UNITED STATES PATENT AND TRADEMARK OFFICE

10/784,759

Office Action Summary	Application No.		Applicant(s)	
	10/784,759		KANG, LAI-O	
	Examiner		Art Unit	
	Zachary M. Pape		2835

DETAILED ACTION

Fig 1.

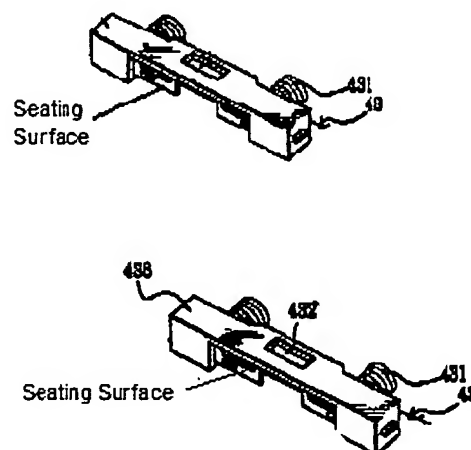
15. With respect to claim 18, Hsu et al. further teaches a pressure member (436) seated in the seating groove (443) and having a seating surface (See Fig 1) on one side thereof determining one side of the passage hole, and a resilient member (431) coupled to another side of the pressure member (436).
